LHAP MSCP (SSD 10388) - Addendum Letter

Liverpool Hospital
Elizabeth Street, Liverpool
NSW 2170
200811 SSDA MSCP Addendum (01)

APPENDIX A – ARCHITECTURAL DRAWING AMENDMENTS

DRAWING
GA LEVEL 07
PRINT DATE
11/08/2020

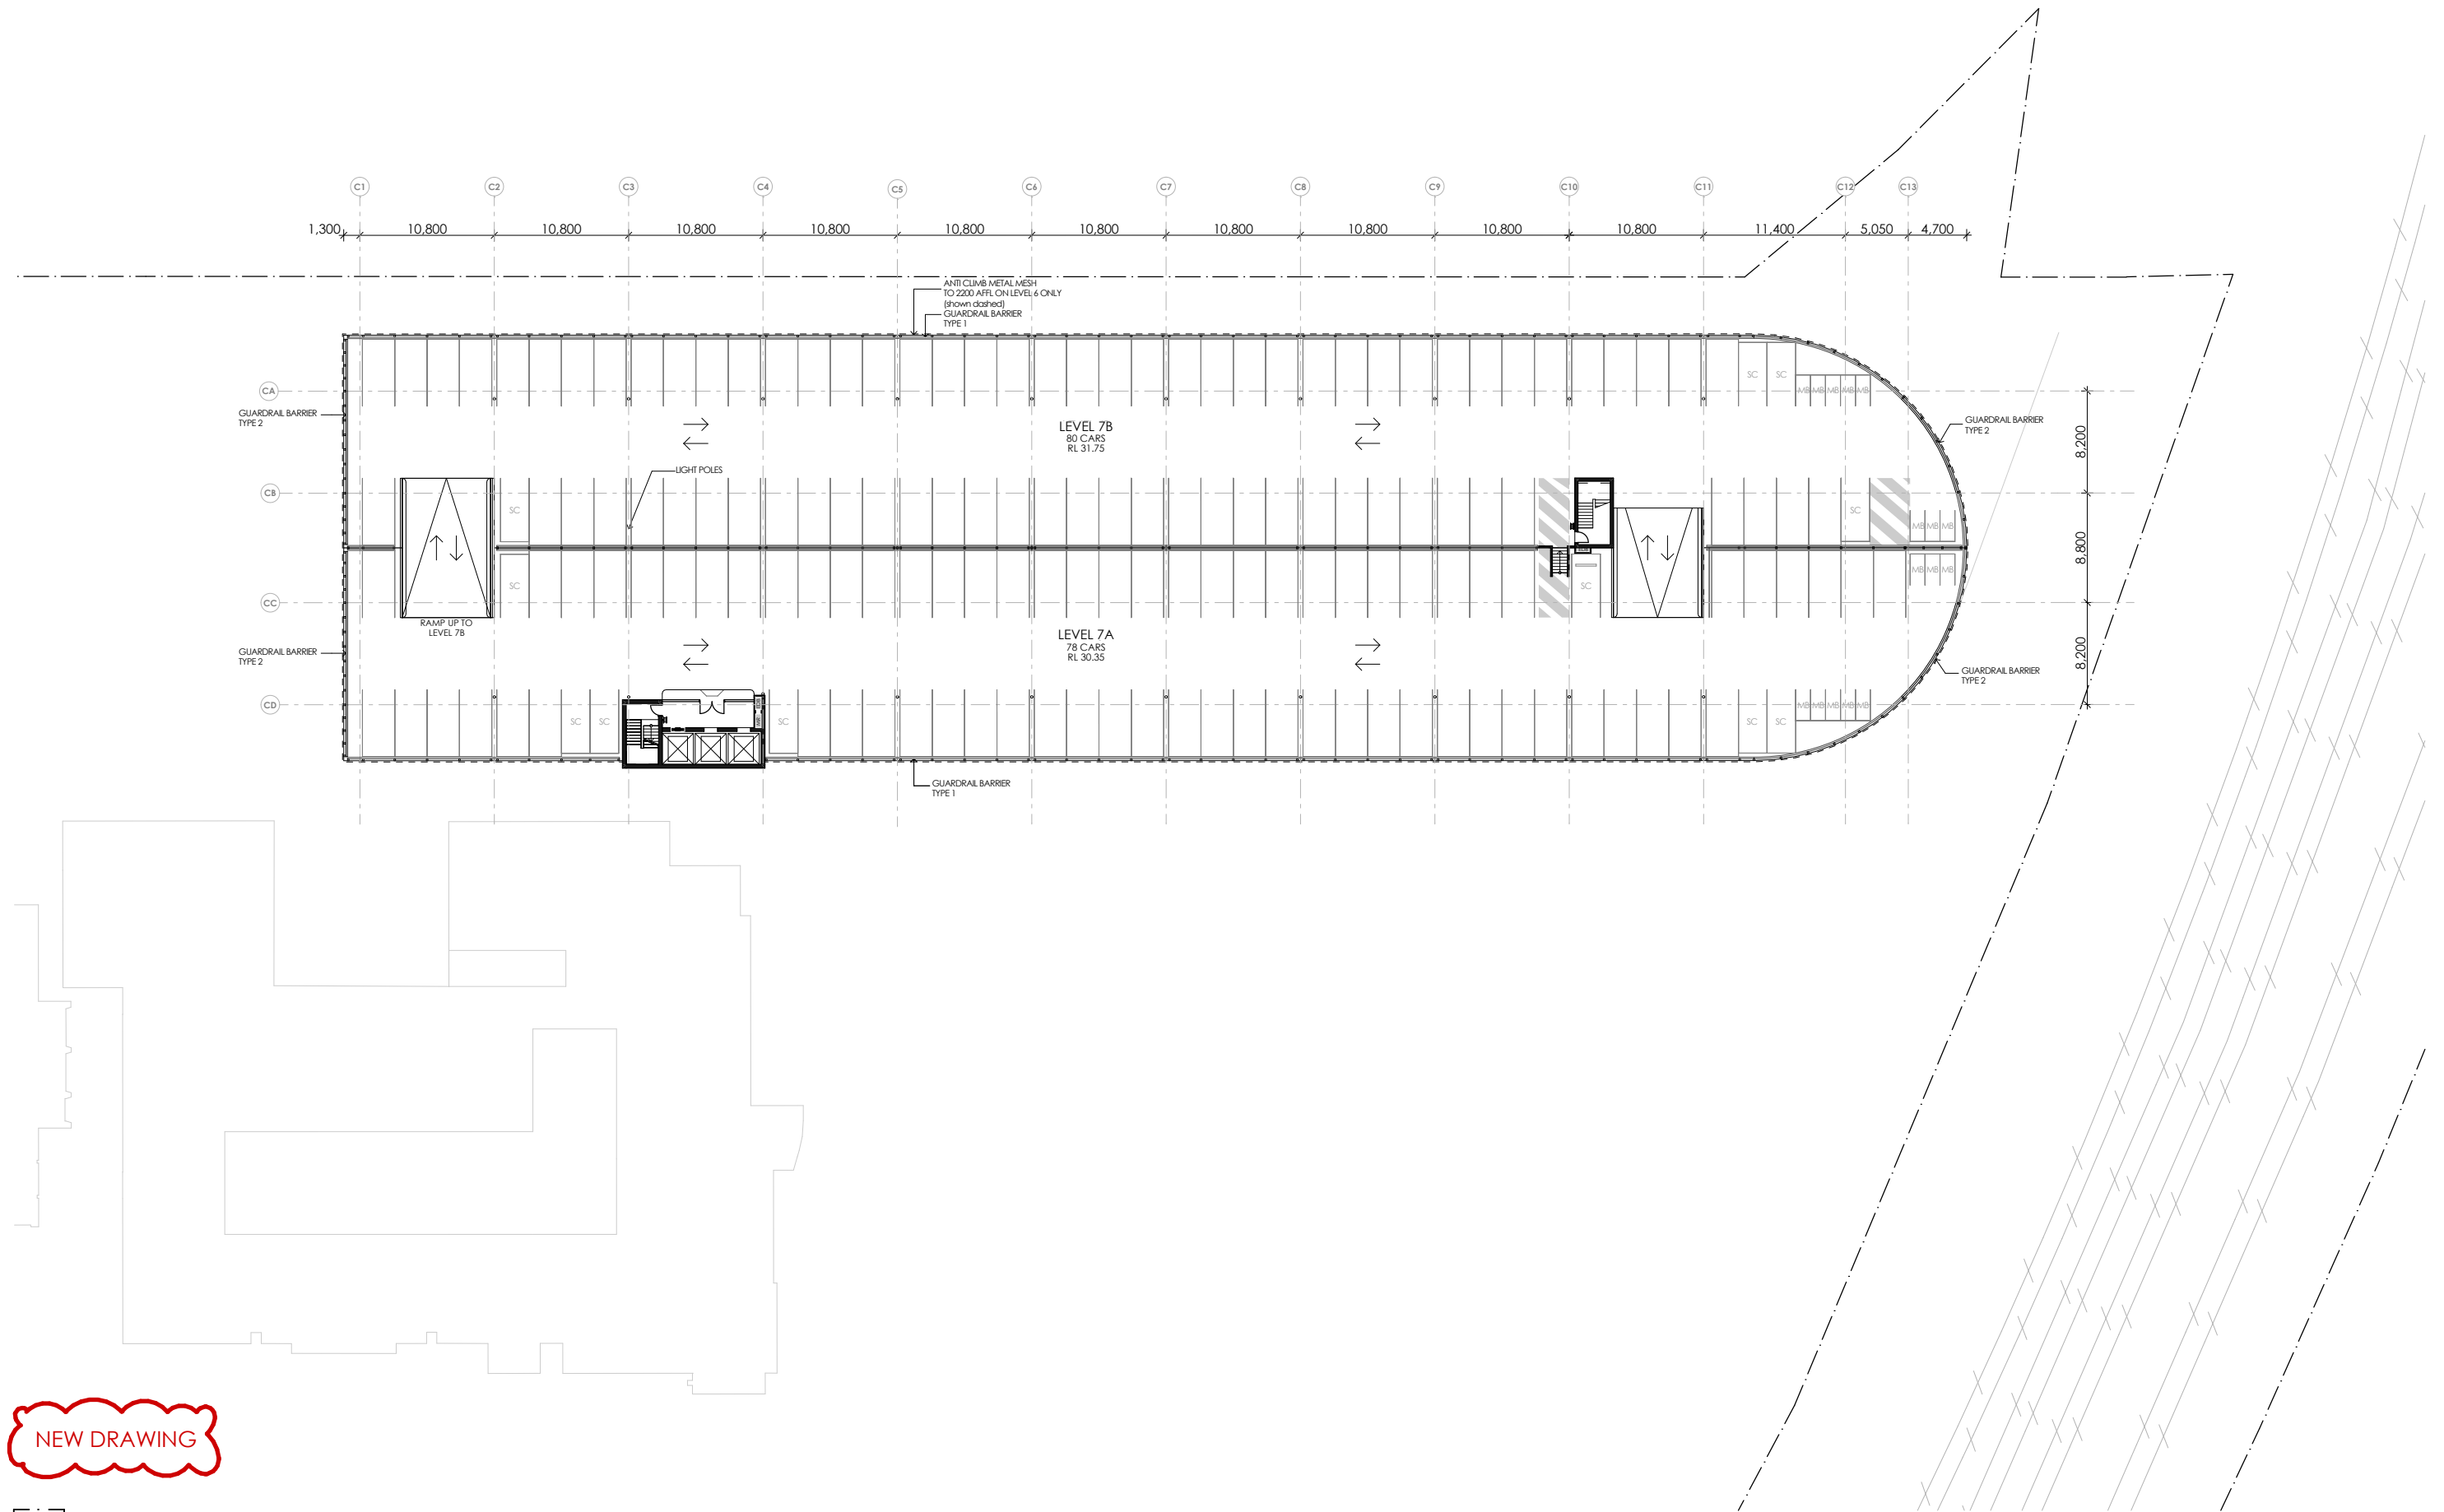
A-SSDA-MW-27 GA LEVEL 07 (new drawing)

- Additional level (Level 7) added
